McPhillamys Gold Project Amendment Report

Prepared for LFB Resources NL
May 2022

AMENDMENT REPORT

MAY 2022

Figure 3-1

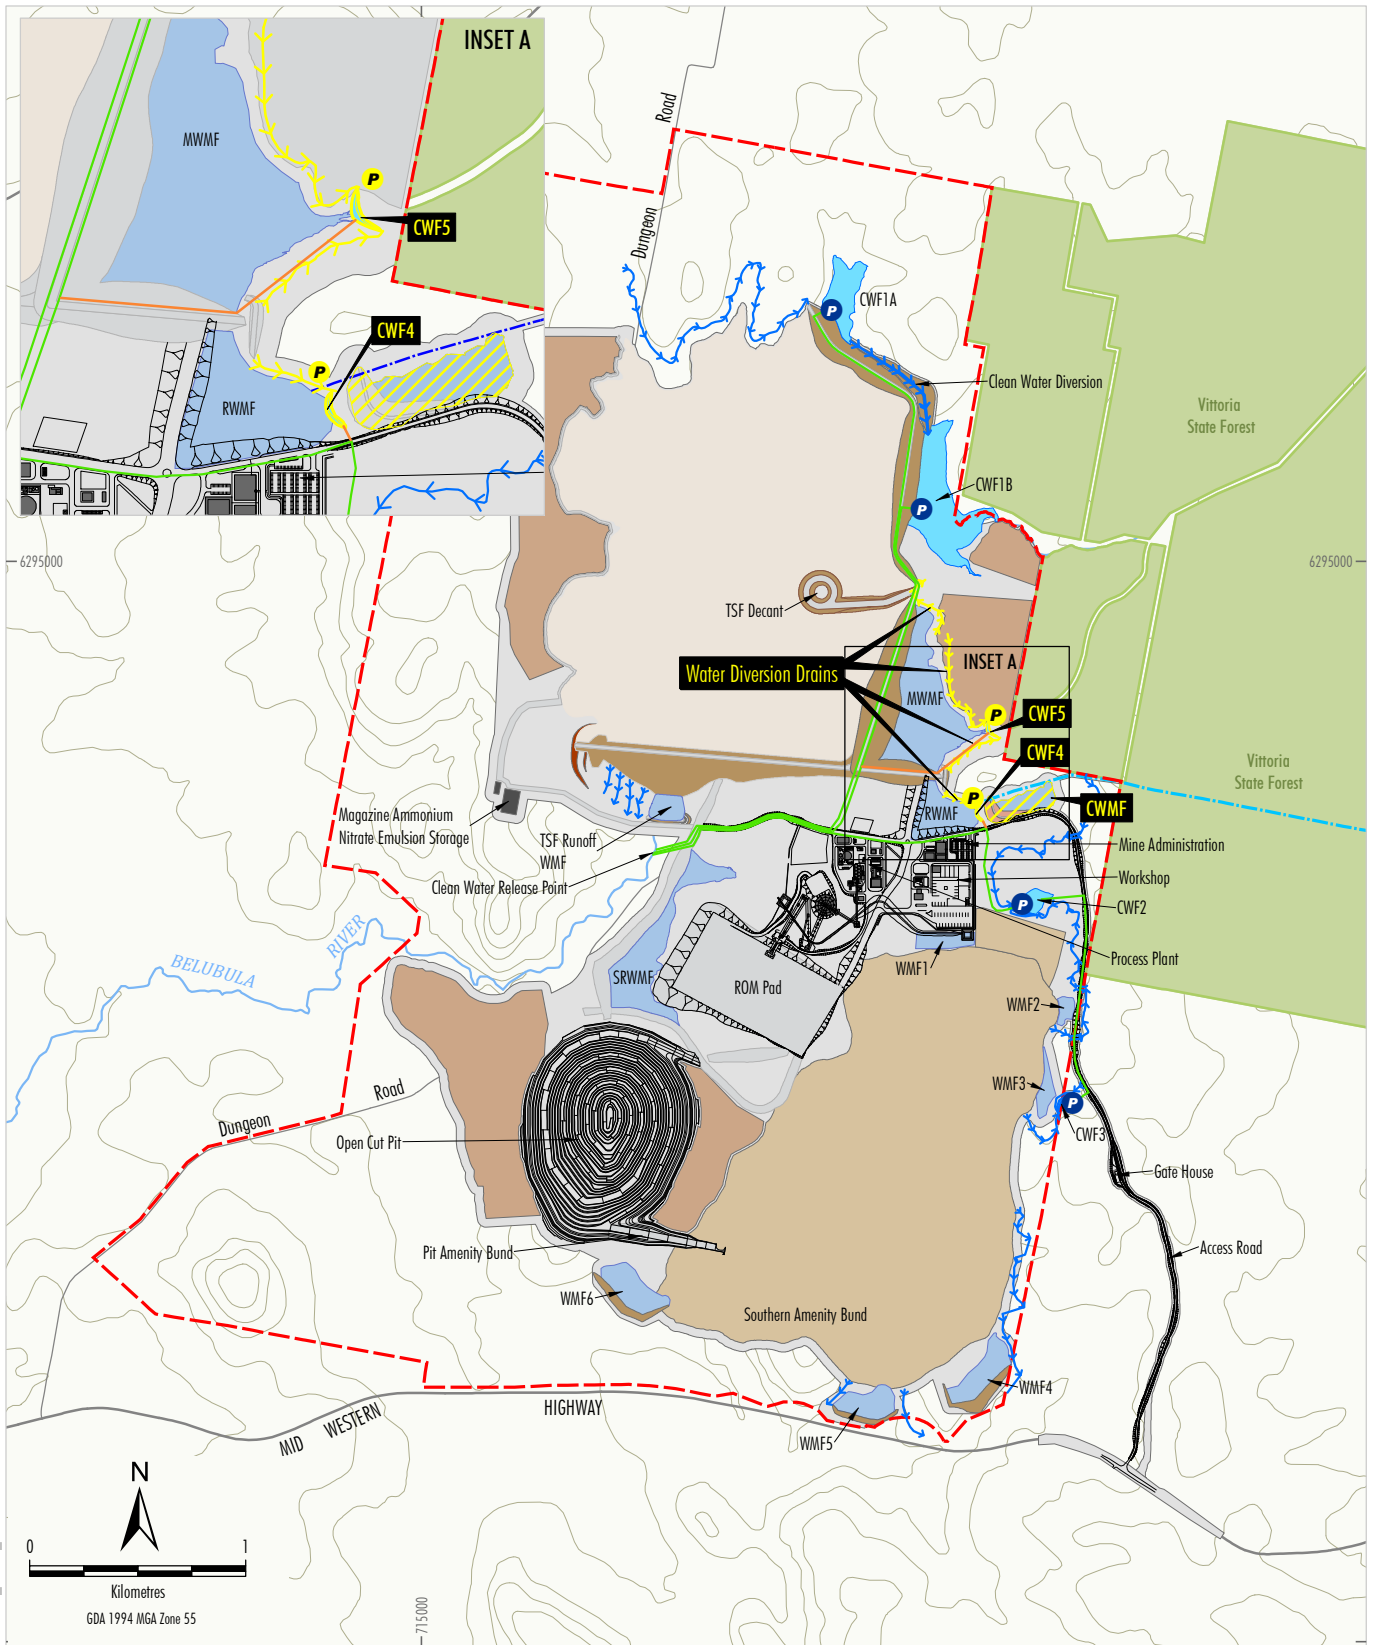
The amended mine site water management system and schematic are shown on Figures 3-1 and 3-2, respectively.

The RWMF would generally remain unchanged from the 2020 Amendment Report except that, consistent with the DPE-Water’s advice, a clean water diversion system would be constructed and operated upstream of the RWMF, including (Figure 3-1):

- a diversion drain;
- a new clean water facility (CWF4) with a capacity of approximately 1.6 million litres (ML); and
- pumps and pipelines to convey water captured in CWF4 to the Belubula River downstream of the mine site (at the stilling basin downstream of the SRWMF).

The MWMF was proposed to contain operational water collected on-site in the 2020 Amendment Report. Although there is no change to the operation of the MWMF, consistent with the DPE-Water’s advice, it is proposed to construct and operate a clean water diversion system upstream of the MWMF, including (Figure 3-1):

- three diversion drains;
- a new clean water facility (CWF5) with a capacity of approximately 3 ML; and
- pumps and pipelines to convey water captured in CWF5 to the Belubula River downstream of the mine site (at the stilling basin downstream of the SRWMF).

Since the preparation of the 2020 Amendment Report, the requirement for minor changes to the MLA 574 boundary in the vicinity of WMF5 have been identified based on the outcomes of ongoing landholder consultation. The amended MLA 574 boundary is shown on Figure 3-1.

Figure 3-3

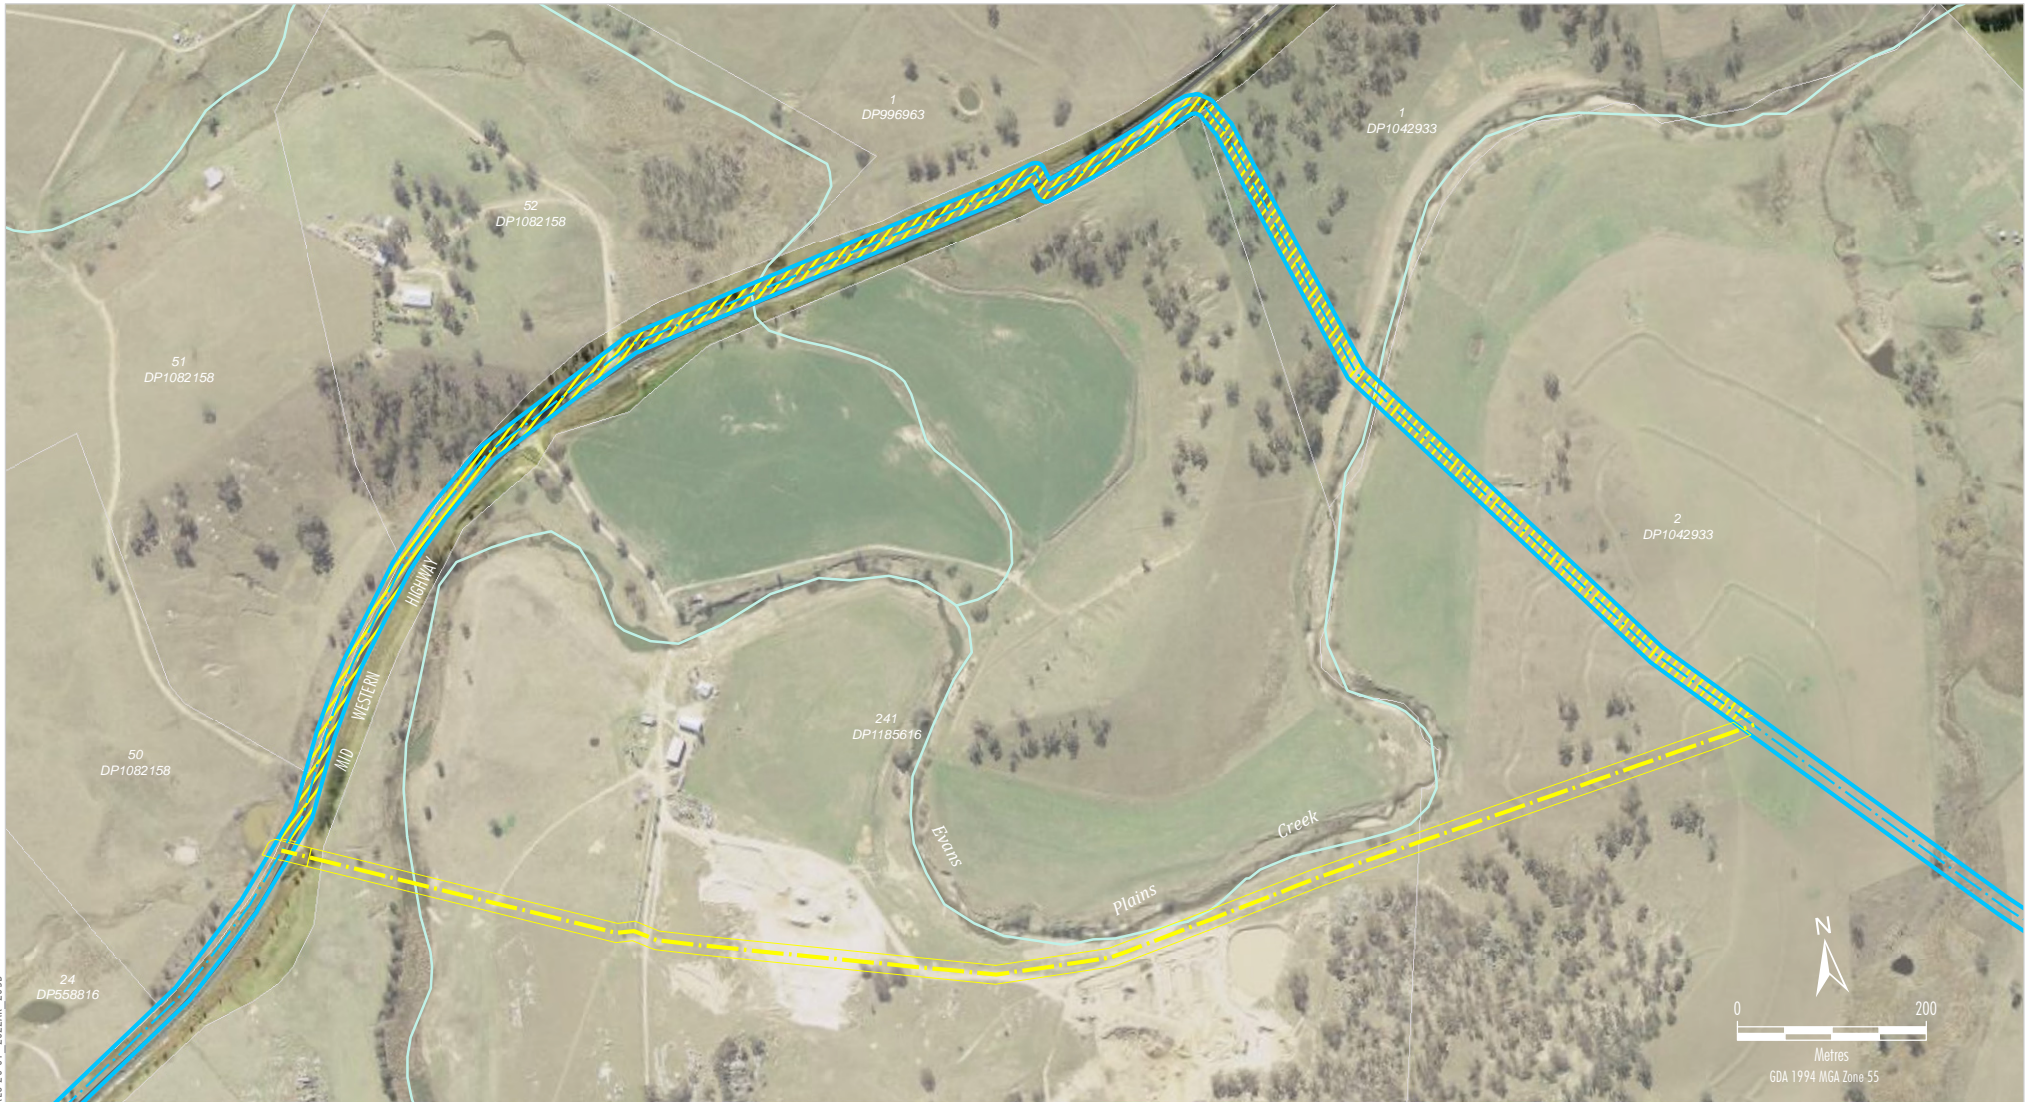
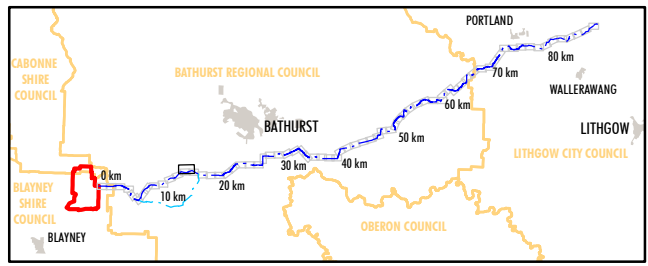
A section of the northern option of the water supply pipeline is proposed to be realigned based on the outcomes of landholder consultation. The realigned section of the water supply pipeline would be approximately 1.6 km in length which is approximately 0.6 km shorter than the section of the 2020 Amendment Report water supply pipeline that it would replace (Figure 3-3).

The water supply pipeline was proposed to cross Evans Plains Creek using open trenching techniques. The realigned water supply pipeline would cross Evans Plains Creek approximately 2.3 km upstream of the original crossing point (Figure 3-3). The crossing would be undertaken using open trenching techniques consistent with the 2020 Amendment Report. The realigned water supply pipeline would avoid crossing one unnamed watercourse (Figure 3-3).

In addition, the surface development area associated with the now amended section of the 2020 Amendment Report northern alignment water supply pipeline would no longer be required resulting in a net reduction in surface development area (Figure 3-3).

In addition, the amended water supply pipeline alignment would avoid trenching of an unnamed drainage line (Figure 3-3). Therefore, there would be a minor reduction in potential impacts as a result of the avoidance of trenching of this watercourse crossing.

Figure 3-4

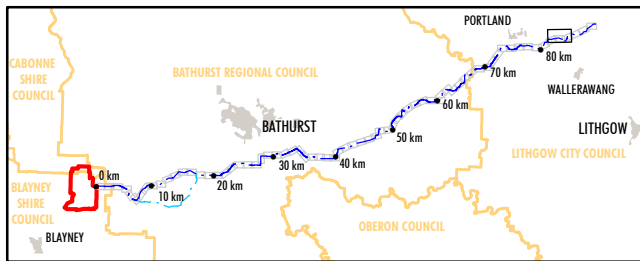
A Mount Piper Power Station connection water pipeline was proposed in the 2020 Amendment Report to link the water supply pipeline to the Mount Piper Power Station connection point (i.e. “Blowdown Pond 1”) (Figure 3-4).

Based on consultation with Energy Australia, it is proposed that the Mount Piper Power Station water supply pipeline connection point would be relocated to Pumping Station 2. This would remove the requirement for the Mount Piper Power Station connection water pipeline proposed in the 2020 Amendment Report (Figure 3-4).

No additional surface development area would be required at Pumping Station 2. In addition, the surface development area associated with the Mount Piper Power Station connection water pipeline proposed in the 2020 Amendment Report would no longer be required resulting in a net reduction in surface development area and reduction in the overall pipeline length by approximately 0.9 km (Figure 3-4).
